**From:** Hoellman, Jordan  
**Sent:** Monday, June 20, 2016 12:39 PM  
**To:** Vogle PEmails  
**Subject:** IRWST Minimum Screen Area Change and Containment Recirculation Screen Protective Plate Dimension Change - Non-Proprietary slides  
**Attachments:** 2016-06-23 Non-prop slides - Debris Screen Related Dimensions.pdf

# IRWST Minimum Screen Area Change and Containment Recirculation Screen Protective Plate Dimension Change (Non-Proprietary)

06/23/2016

Table 6.3-2 (Sheet 2 of 2)  
Component Data - Passive Core Cooling System

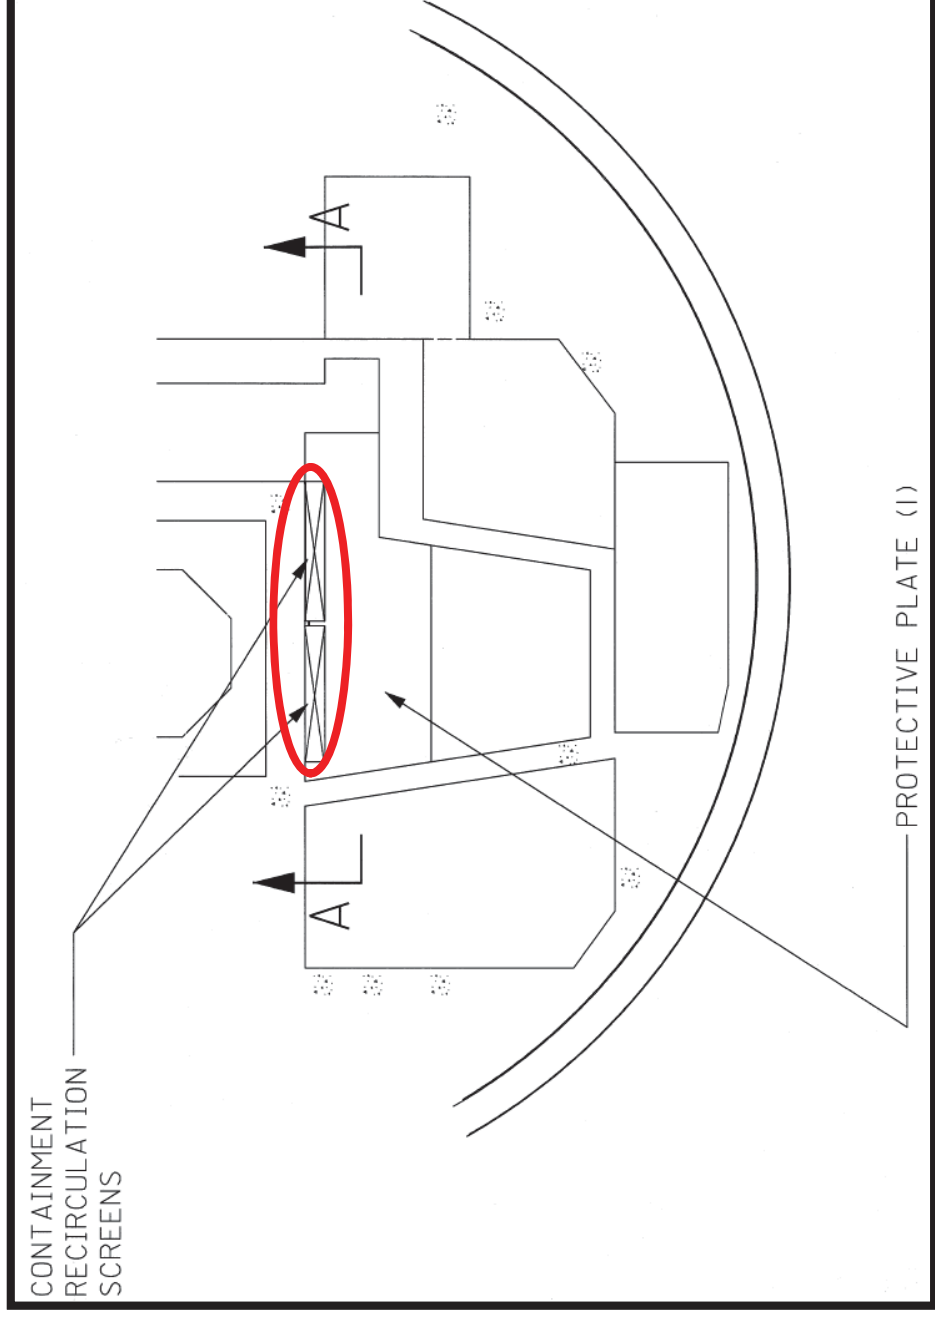
Screens	<u>IRWST</u>	<u>Containment Recirculation</u>
Number	3	2
Surface area, screen (square feet)	IRWST Screens A and B: ≥ 500 per screen IRWST Screen C: ≥ 1000 ft <sup>2</sup>	≥ 2,500 per screen
Material	Stainless steel	Stainless steel
AP1000 equipment class	C	C

IRWST Screens A and B:  
≥ 500 per screen  
IRWST Screen C: ≥ 1150 ft<sup>2</sup>

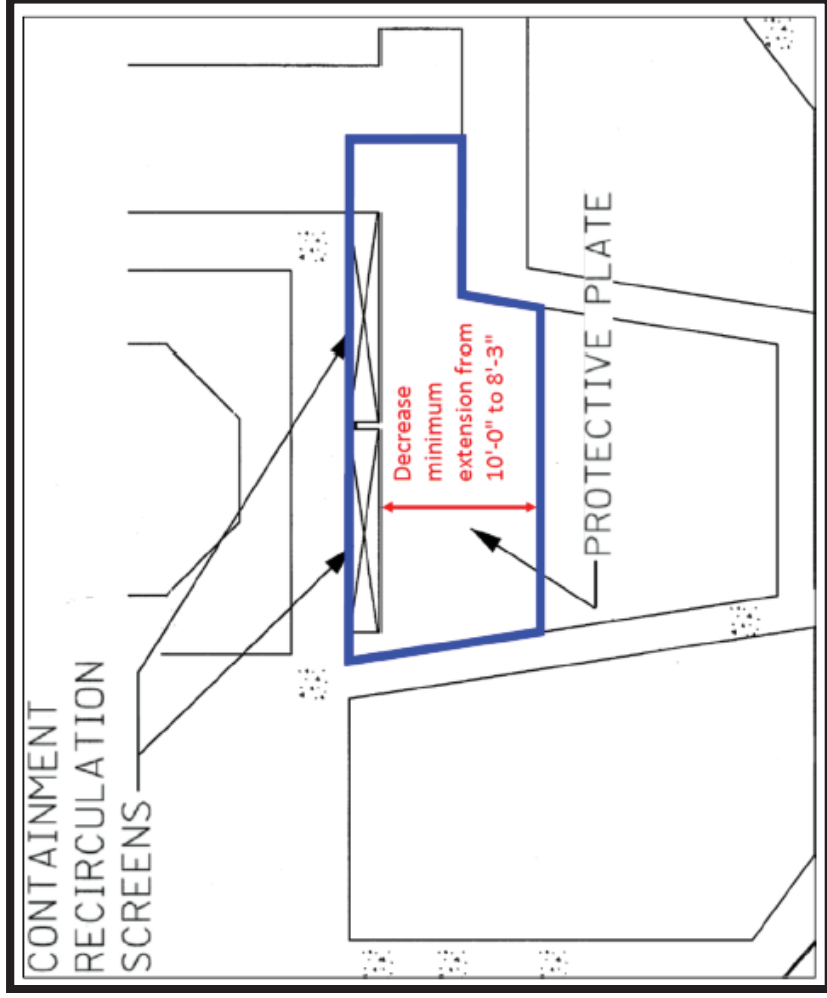
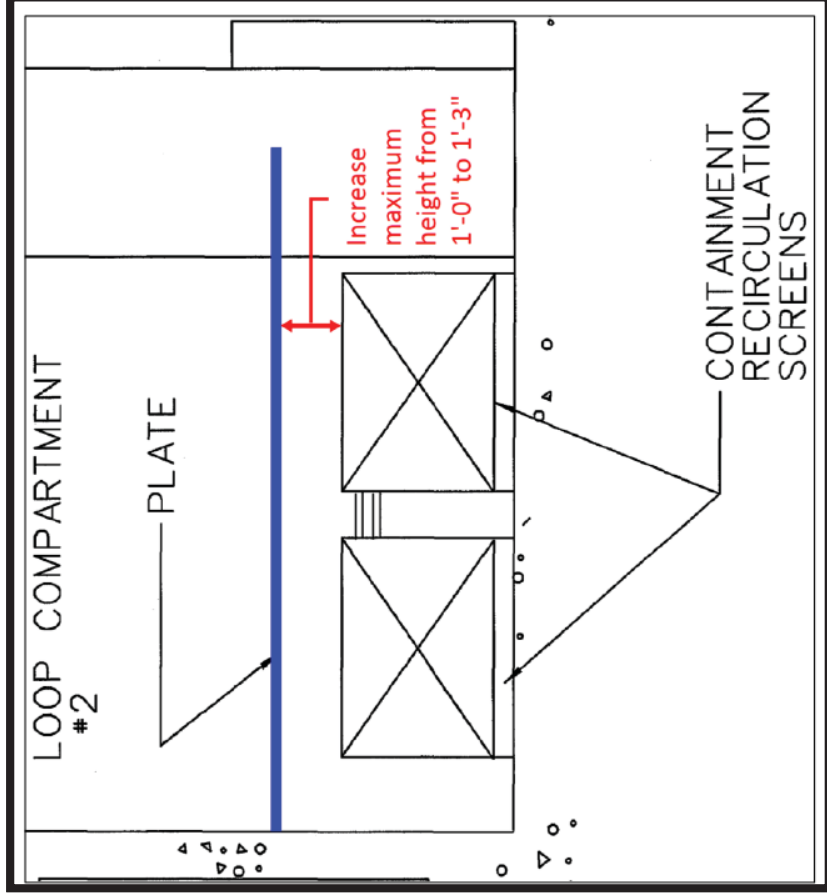
- As identified in UFSAR Subsection 6.3.2.2.7.3, the screen protective plate is provided to prevent nonsafety-related (Service Level II) coating debris that could detach in the post-accident environment from falling too close to the recirculation screens, where it could be transported to the screens.
- The UFSAR currently specifies that the plates located over the containment recirculation screen extend at least 10 feet perpendicular to the side of the screen surface
  - In order to facilitate reactor coolant pump maintenance, additional clearance is proposed in this LAR.
- The UFSAR currently specifies that the plates located over the containment recirculation screen are no more than 1 ft. above the top of the screen.
  - Changes are proposed to clearly specify where the measurements will be taken and account for the final location of the plate

- Specify in UFSAR Subsection 6.3.2.7.3 that the north edge of the north containment recirculation screen face is located at least 3 feet, 6 inches from the north corner of the west wall of steam generator compartment 2
